Access Compliance Report

Public Rights-of-Way

(Island Curb Cuts)

Intersection ID: 44419	Main Street: ARDREY_KELL_RD	Cross Street: PROVIDENCE_RD	Location: E
ADA ID: 3070CA5E9B7A	Curb Cut Type: MedianRefuge2	Initial Pass/Fail: Fail	Overall Compliance: No
Codes/Mitigation Info/Possible Solution		Field Measurements/Component Compliance	
Severity Score: 0

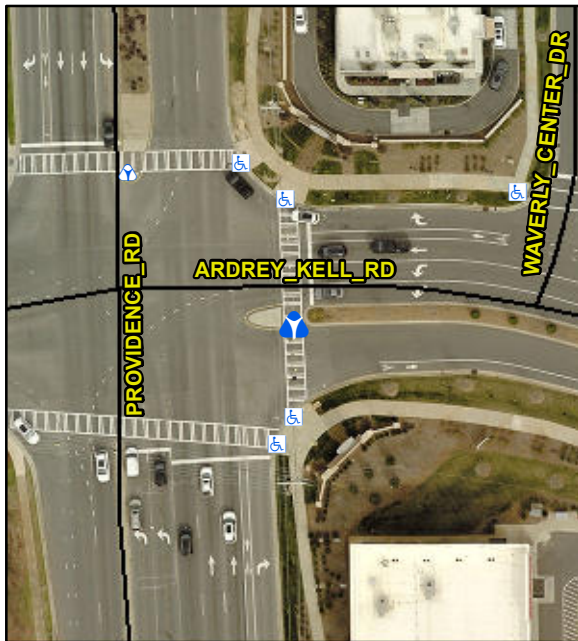
Compliance	Description	Data	Compliance	Description	Data
Yes	Refuge 1 Length (In)	66.0	N/A	Gutter 1 Ponding?	N/A
Yes	Refuge 1 Width (In)	151.0	N/A	Gutter 1 Lip Ht (In)	N/A
Yes	Refuge 1 Slope (%)	0.5	N/A	Gutter 1 Slope (%)	N/A
Yes	Refuge 1 X Slope (%)	3.1	N/A	Gutter 1 X Slope (%)	N/A
N/A	Painted X Walk1?	Yes	N/A	DWS 1 Provided?	N/A
N/A	X Walk 1 Direction	To S	N/A	DWS 1 Contrast?	N/A
N/A	X Walk 1 Width (In)	105.0	N/A	DWS 1 Length (In)	N/A
N/A	Road 1 Slope (%)	0.3	N/A	DWS 1 Full Width?	N/A
N/A	Road 1 X Slope (%)	3.6	N/A	DWS 1 Offset (In)	N/A
Yes	Refuge 2 Length (In)	66.0	N/A	Gutter 2 Ponding?	N/A
Yes	Refuge 2 Width (In)	151.0	N/A	Gutter 2 Lip Ht (In)	N/A
Yes	Refuge 2 Slope (%)	1.6	N/A	Gutter 2 Slope (%)	N/A
Yes	Refuge 2 X Slope (%)	2.8	N/A	Gutter 2 X Slope (%)	N/A
N/A	Painted X Walk2?	Yes	N/A	DWS 2 Provided?	N/A
N/A	X Walk 2 Direction	To N	N/A	DWS 2 Contrast?	N/A
N/A	X Walk 2 Width (In)	105.0	N/A	DWS 2 Length (In)	N/A

N/A	Road 2 Slope (%)	0.4	N/A	DWS 2 Full Width?	N/A
N/A	Road 2 X Slope (%)	2.7	N/A	DWS 2 Offset (In)	N/A
N/A	Refuge 3 Length (in)	N/A	N/A	Gutter 3 Ponding?	N/A
N/A	Refuge 3 Width (in)	N/A	N/A	Gutter 3 Lip Ht (in)	N/A
N/A	Refuge 3 Slope (%)	N/A	N/A	Gutter 3 Slope (%)	N/A
N/A	Refuge 3 XSlope (%)	N/A	N/A	Gutter 3 XSlope (%)	N/A
N/A	Painted X Walk3?	N/A	N/A	DWS 3 Provided?	N/A
N/A	X Walk 3 Direction	N/A	N/A	DWS 3 Contrast?	N/A
N/A	X Walk 3 Width (in)	N/A	N/A	DWS 3 Length (in)	N/A
N/A	Road 3 Slope (%)	N/A	N/A	DWS 3 Full Width?	N/A
N/A	Road 3 XSlope (%)	N/A	N/A	DWS 3 Offset (in)	N/A
Yes	Any Obstructions?	N/A	N/A	Storm Grate/Utility Hazard?	N/A
N/A	Obstruction Type		N/A	Storm Grate/Utility Type	
		N/A			N/A
N/A	Surface Condition	Good

Remove & Replace Entire Refuge.
